Re: Draft Environmental Impact Report for San Francisco Overlook
Development [Planning Dept. Case No. 2004.0093E]

Thank you for the opportunity to comment on the Draft Environmental Impact Report for the San Francisco Overlook Development residential project ("DEIR"). These comments are submitted on behalf of the Mount Sutro Homeowners Association ("Association") representing residents that live near the site of the proposed San Francisco Overlook residential project ("Project"). This ambitious Project proposes to shoehorn a large and dense development into a very constrained site with extraordinarily steep terrain. The pictures on the next page and attached hereto as Exhibit 1 illustrate just how steep and constrained the site is. More importantly, approval of the Project as currently proposed would jeopardize the health, safety and well being of these residents and their property by putting them at substantial risk of being exposed to landslides, among other hazards. As further described below, the DEIR does not comply with the requirements of the California Environmental Quality Act ("CEQA") because it fails to study all potentially significant environmental impacts, fails to c

Figure 1

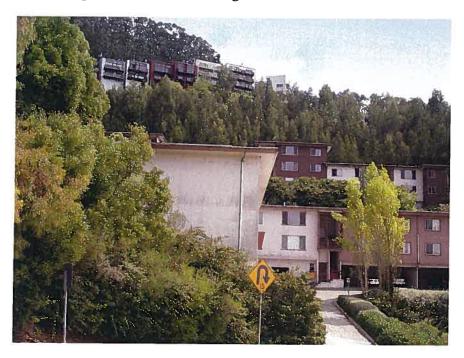
The Project proposes to develop 13 buildings containing 34 units and a private access road in the steeply sloped wooded area that currently exists between the residential buildings shown in the top and bottom of the photo below (Figure 1). Clearly, construction of the Project will rely on complex and extraordinary engineering techniques that will have significant adverse environmental impacts on the surrounding environment.

Figure 3

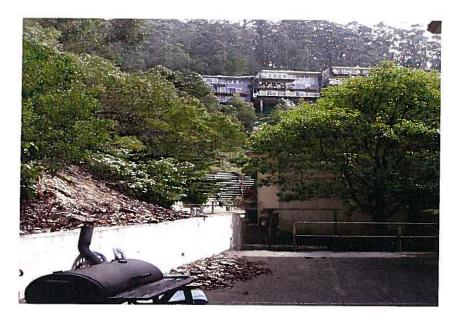
(c) <u>Retaining/Debris Walls</u> The DEIR states that walls will be constructed at the downhill edge of the site to prevent rocks, soil and other materials from falling onto the property of the downhill neighbors. The downhill neighbors are already exposed to excessive rock and debris flow that existing retaining walls cannot contain, as illustrated on Figure 3 below. (See also photos 8-10, Exhibit 1.)

Once construction begins, even more rock, soil and other debris will fall down the hill. As such, the need for adequate retaining walls during all phases of construction cannot be understated, yet do not appear to be adequately addressed. Also, the developer needs to explain how the contractor proposes to access this area to build the retaining wall that will support the road. Will access be from Lots 25/28 or from the bottom of the hill via 5th Avenue? If from 5th Avenue, the DEIR needs to analyze the impacts associated with construction trucks traveling along that route. If from Lots 25/28, how will cement trucks and other construction vehicles traverse the steep terrain required to access from above? The environmental impacts and hazards associated with such construction activities have not been adequately analyzed in the DEIR.

Figure 4

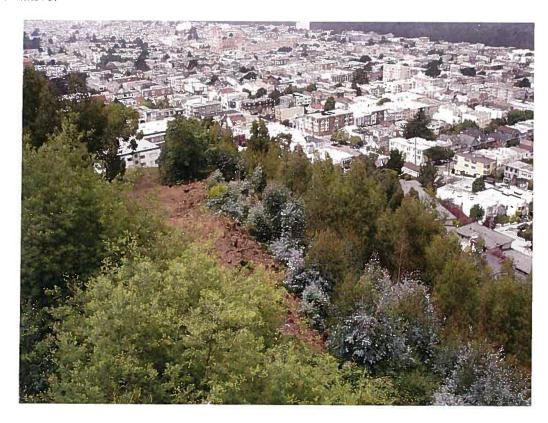
(a) <u>New Alternative</u>. The Association requests consideration of a new Project alternative. This alternative should consider a development featuring a small cluster of homes built at the westerly portion of the Project site. That relatively flat area (see Figure 4 below) could accommodate three to five single family homes with less than significant impacts to the

3-5 single family residences could be constructed on the relatively flat area shown here.
